DOCUMENT 009113.01 – ADDENDUM 01

- A. Project Name: Middle Park High School Summer 2026 Renovation
 - 1. Owner: East Grand School District No. 2
 - 2. Owner Project Number <Owner Project Number>.
 - 3. Architect: Hord Coplan Macht (HCM).
 - 4. Architect Project Number: 222000.30

A-103P/A-103P 1/8" = 1'-0"

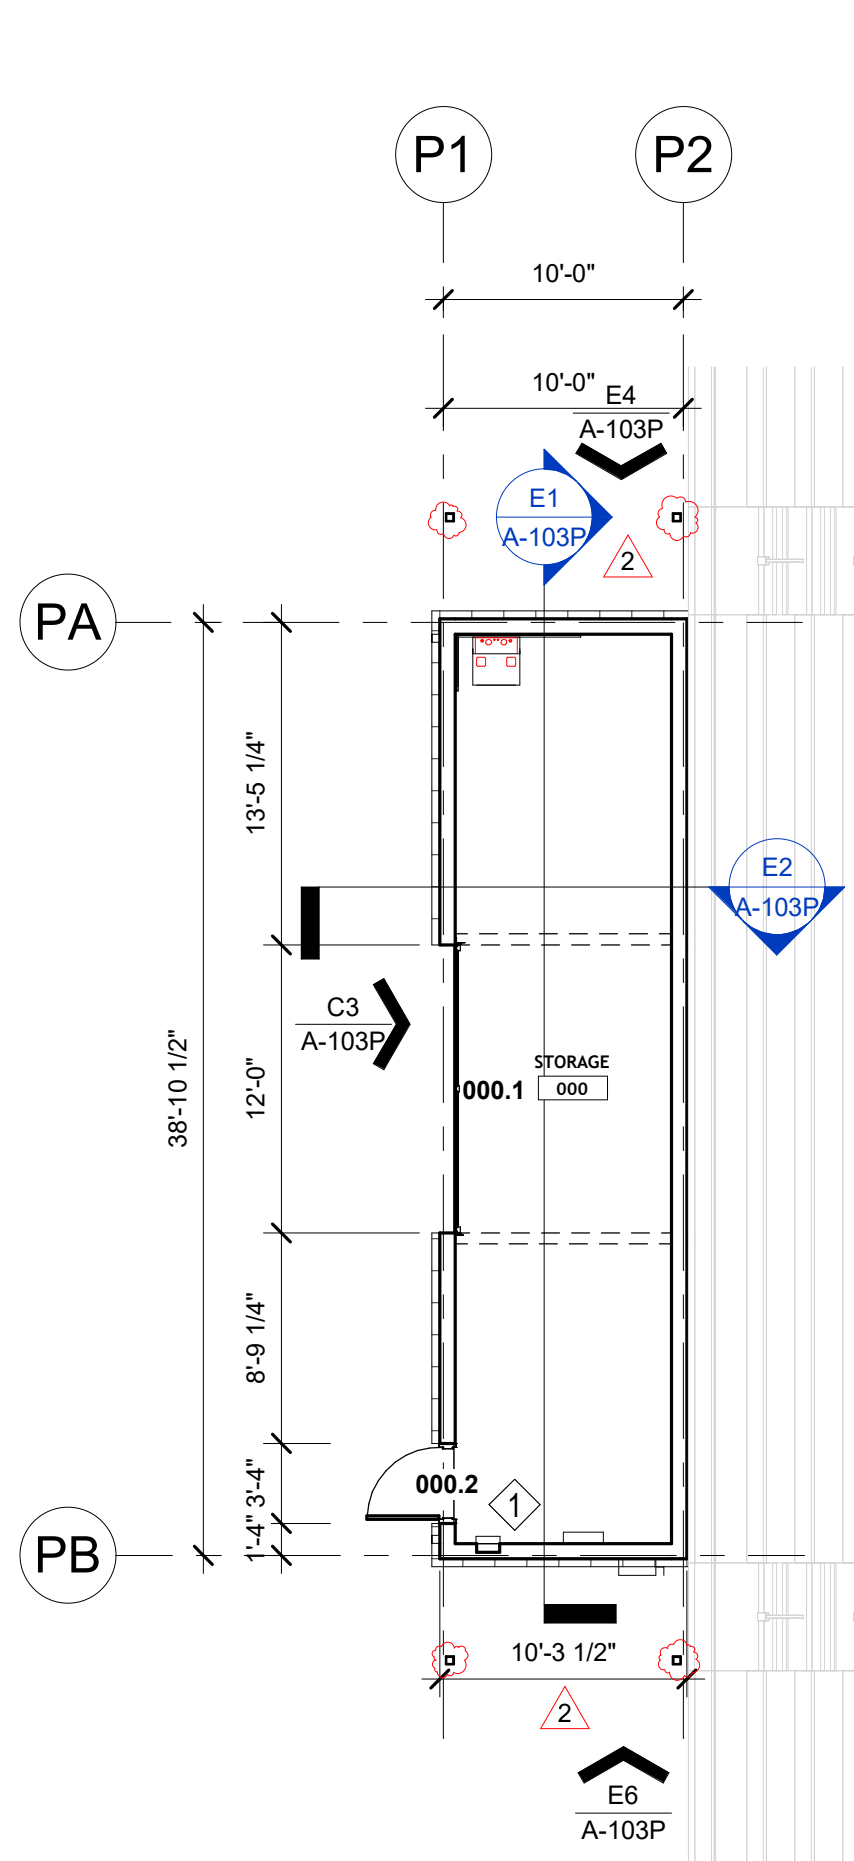
- A. Revision to sheet A-103P.

- 1. Revise sandstone wall extent and pattern as indicated on 1/L3.04 and 4/L3.04.

1. Comment: Press box stairs are shown with exposed steel posts on the structural drawings (sheet S-100), but these posts are not shown on the architectural (sheet A-103P). Please confirm these posts are to be painted along with the stair assembly

2. Comment: Bleacher railing shows new chain-link fabric being installed on existing angle iron (note 32-1/ A103P), please clarify if the existing angle iron will require repair or refinishing.

3. Comment: Press box cement board siding shows color as TBD (note 7-3/A-103P), is this siding to be pre-finished from the factory or field painted?
 - a. Response: All cement board siding to be pre-finished. Cement board is revised under the press box windows adjacent to the top row of bleacher seats to be flush panel, rather than lap siding. See updated material notes and drawings on sheet A-103P. Revised window schedule and details provided on updated sheet A-611P.

4. Comment: Existing bleachers show new aluminum handrail on one side, is this handrail expected to match the existing bleacher handrailing? If so, please provide an elevation or attachment detail of the existing railing if possible.

- a. Response: Steel columns are added to the press box drawings and called out to have high performance coating, with added material note 9-1. See attached revised sheet A-103P.

- a. Response: Intent is to retain structural angle posts for the bleachers. There does not appear to be an alternative solution to mount the fabric fence. These posts are assumed to be in good condition but will need to be observed in field to confirm. Posts to be painted with high performance coating. Revised sheet A-103P incorporates these updates.

- a. Response: The intent is to match the same handrail profile. The existing handrail and attachment are steel. The intent is for the new handrail to be aluminum to match the bleacher system and prevent rusting. Elevation of railing added to the press box drawings, and a photo of the existing post mounting added to sheet A-103P.

M-111E

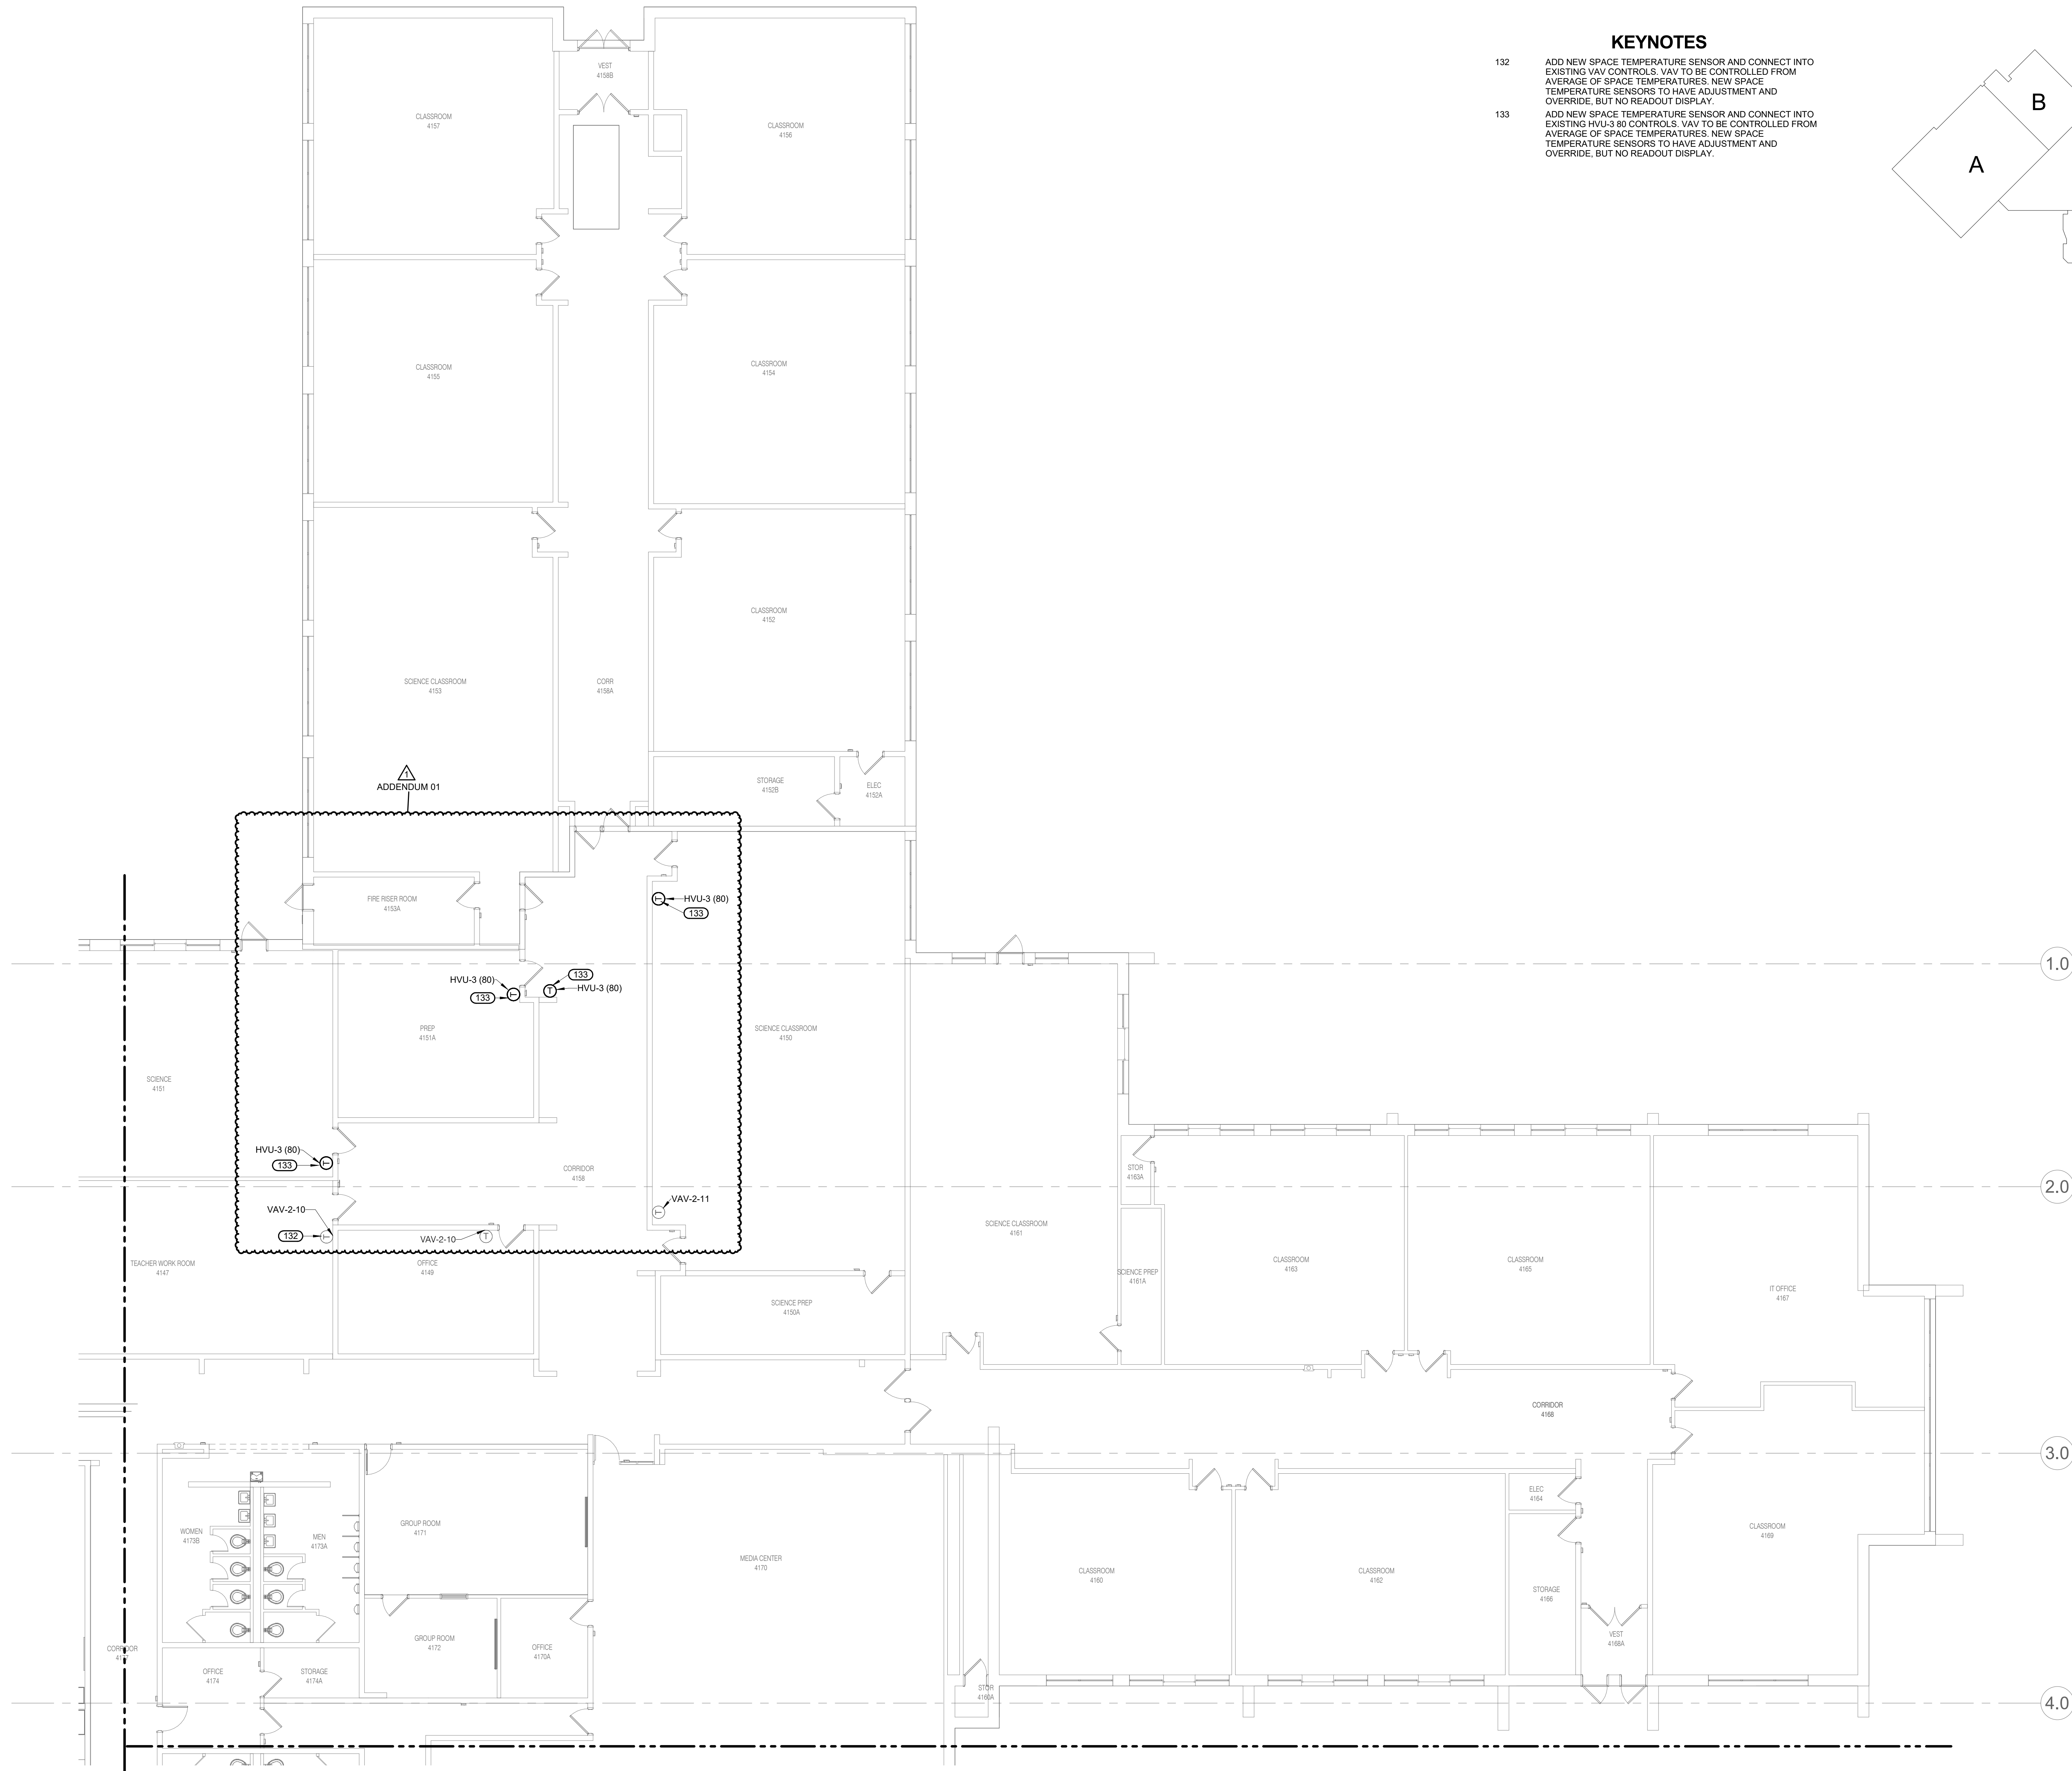
- C. Revision to sheet M-111E.

- 1. Add sheet, add new thermostats.

- 132 ADD NEW SPACE TEMPERATURE SENSOR AND CONNECT INTO
EXISTING VAV CONTROLS. VAV TO BE CONTROLLED FROM
AVERAGE OF SPACE TEMPERATURES. NEW SPACE
TEMPERATURE SENSORS TO HAVE ADJUSTMENT AND
OVERRIDE, BUT NO READOUT DISPLAY.
- 133 ADD NEW SPACE TEMPERATURE SENSOR AND CONNECT INTO
EXISTING HVJ-380 CONTROLS. VAV TO BE CONTROLLED FROM
AVERAGE OF SPACE TEMPERATURES. NEW SPACE
TEMPERATURE SENSORS TO HAVE ADJUSTMENT AND
OVERRIDE, BUT NO READOUT DISPLAY.

M-121D

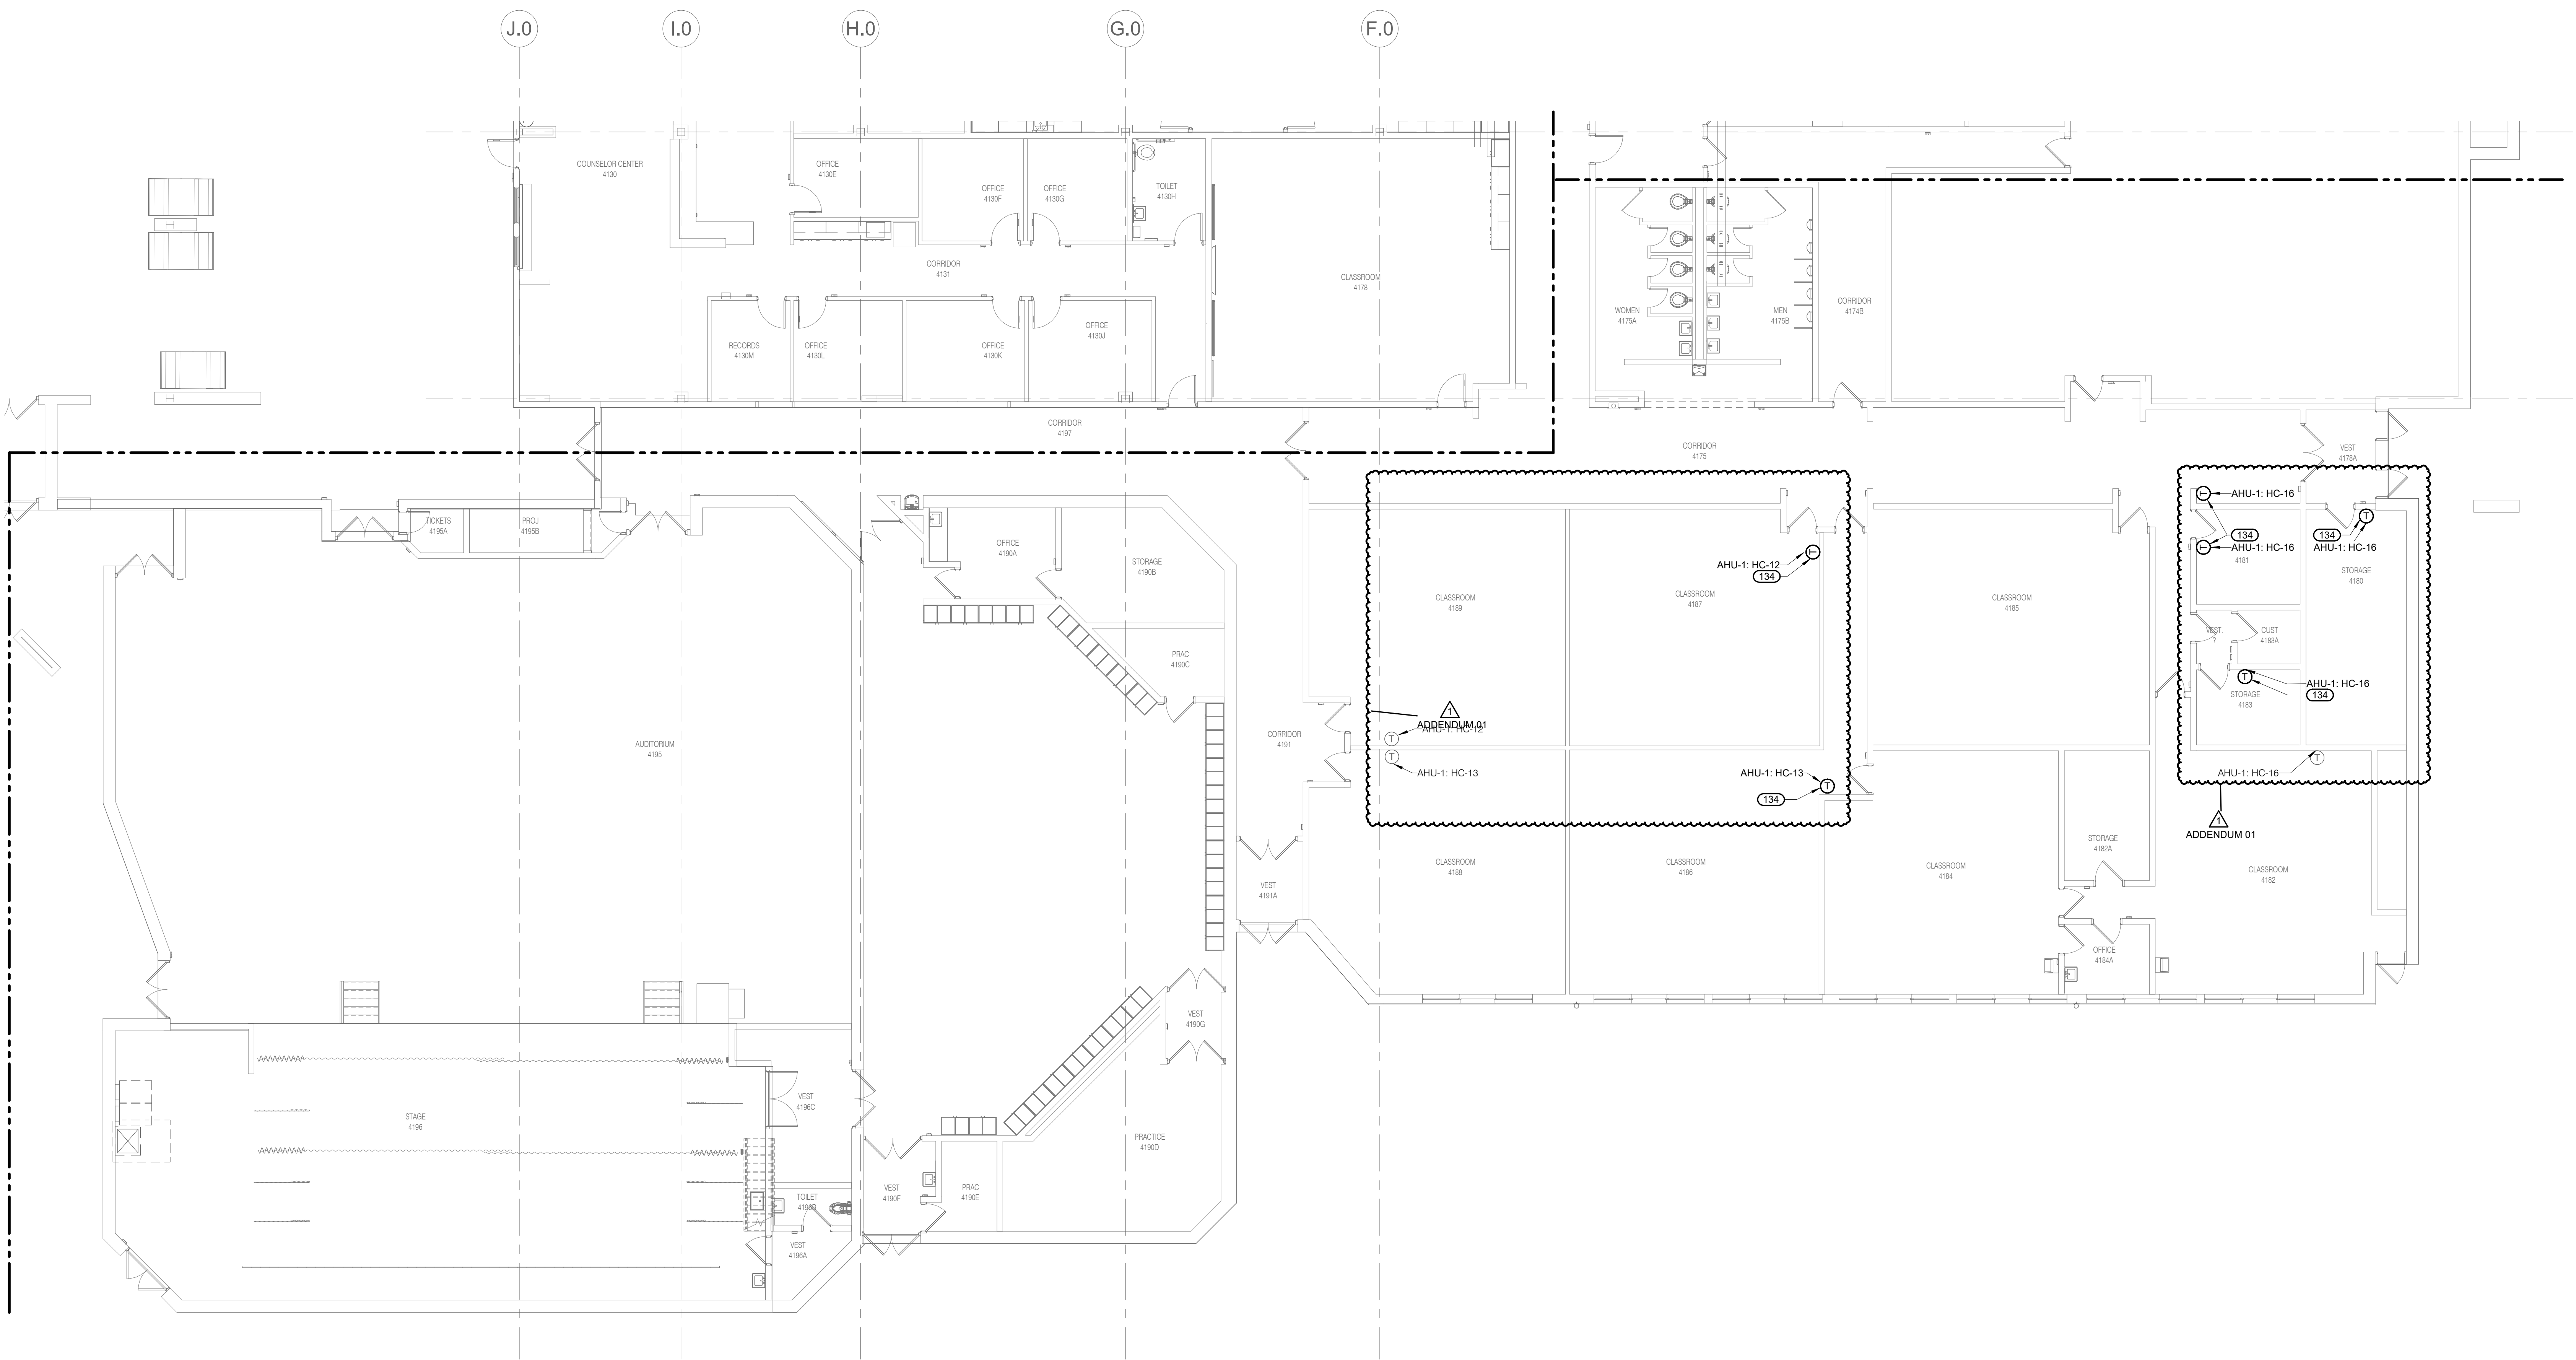
- D. Revision to sheet M-121D.

- 1. Add sheet, add new thermostats.

134 ADD NEW SPACE TEMPERATURE SENSOR AND CONNECT INTO
EXISTING AHU-1 CONTROLS. RE-HEAT COIL TO BE CONTROLLED
FROM AVERAGE OF SPACE TEMPERATURES. NEW SPACE
TEMPERATURE SENSORS TO HAVE ADJUSTMENT AND
OVERRIDE, BUT NO READOUT DISPLAY.
